The City of Grove City

AGENDA

Planning Commission

January 2, 2024

Site Plan Upper Deck Sports Bar

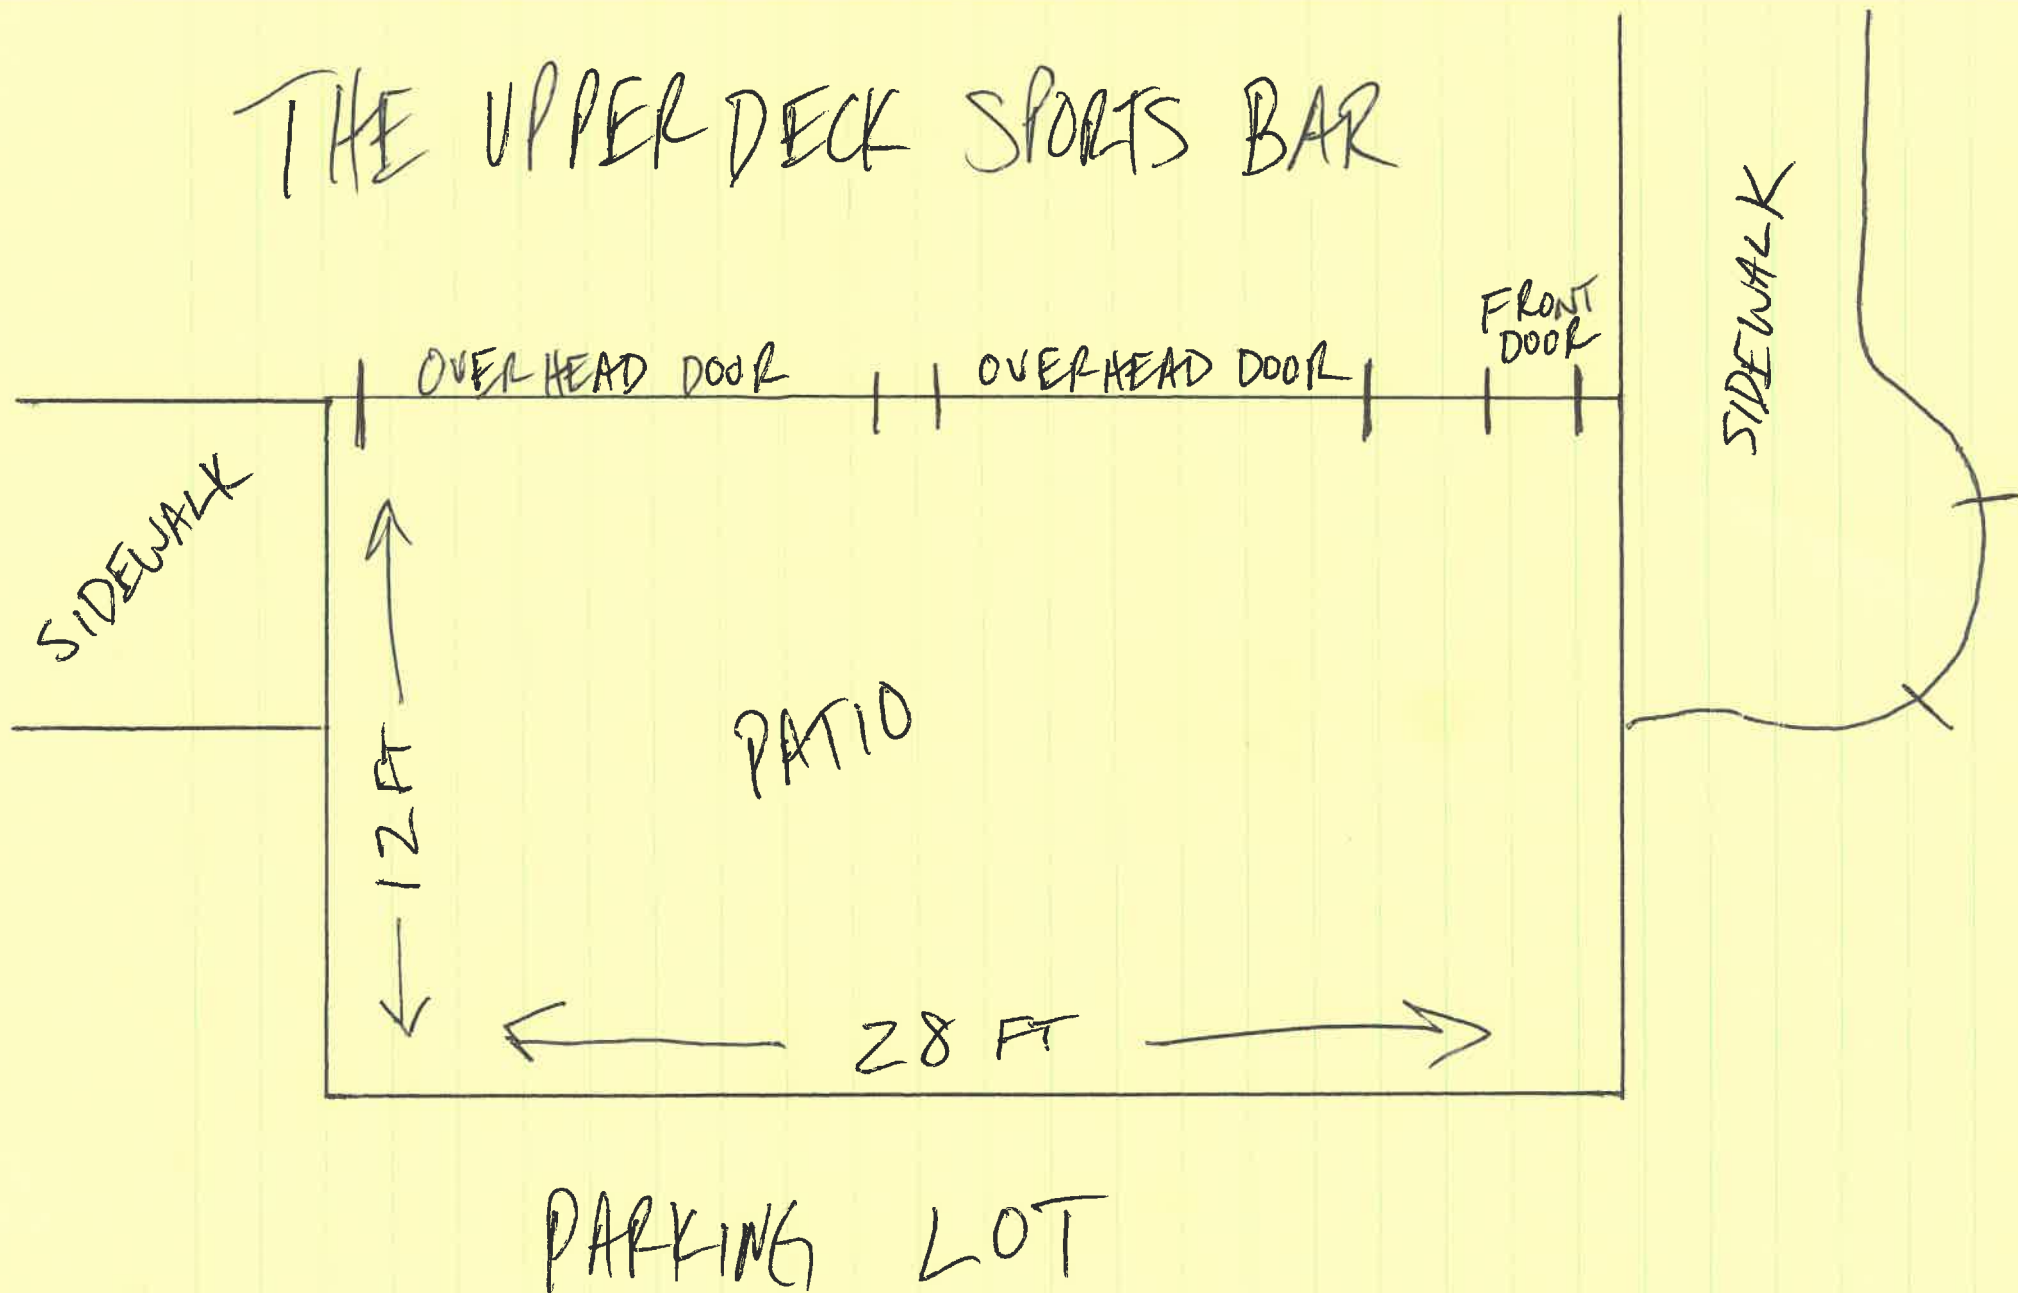
Finding Can be Met: The applicant is proposing landscaping be added to the patio area, as currently none exists along the front of the multi-tenant building. The proposed fence, table and chairs, and bollards have a decorative design and will increase the aesthetics of the area.

Triplex Elevations

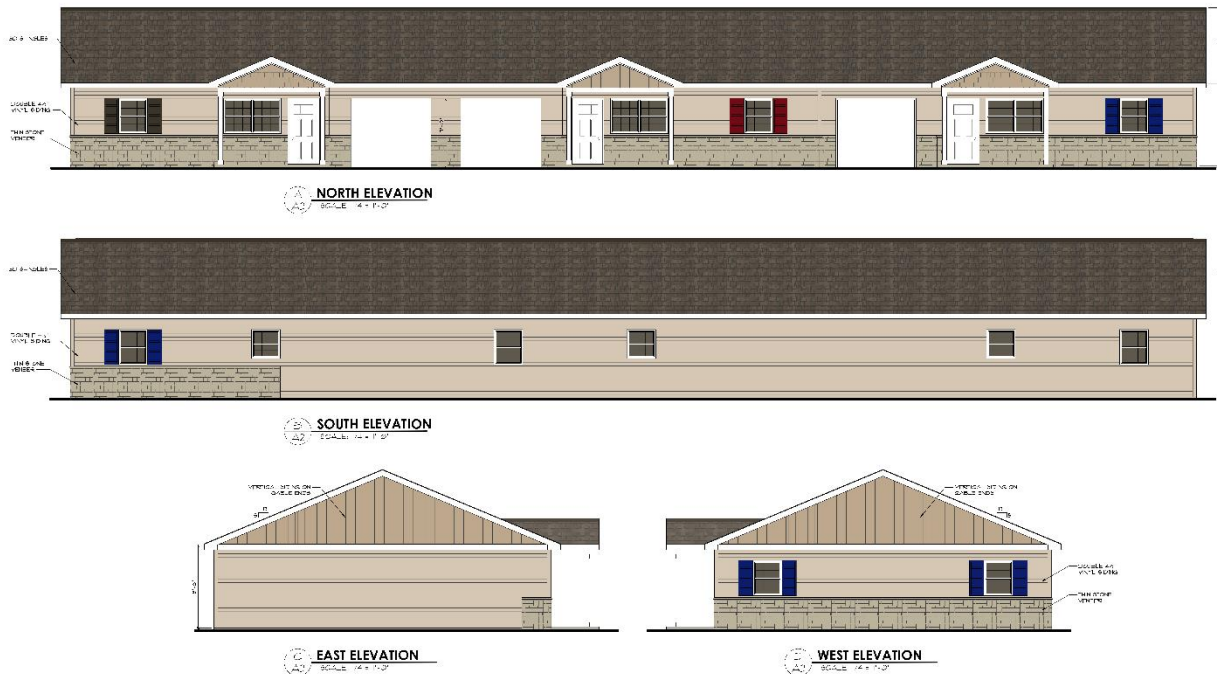
While architectural requirements and building materials will be finalized in the zoning text for the site during the rezoning application, project materials indicate that the proposed structures will be finished primarily in vinyl siding, with 4 ½" vinyl, vinyl cedar shakes, vertical board and batten vinyl siding, and vinyl scallop in the building gables. A stone veneer water table is shown on the elevations, visible from the public right of way. Additionally, materials indicate that the windows visible from the public-right-of way will include shutters.

The proposed elevations do not meet the standard A-1 multi-family zoning requirement that the exterior façade consist of a minimum of 75% brick, stone, and/or stucco; however, the amount of stone shown on elevations is comparable to the multi-family townhomes approved for Beulah Park on the west side of Elm Street which will feature approximately 31% masonry on street-facing elevations. The remaining exterior finishes are also comparable in color and material to those approved for the Beulah Park townhomes and staff believe will provide an appropriate transition for the area.
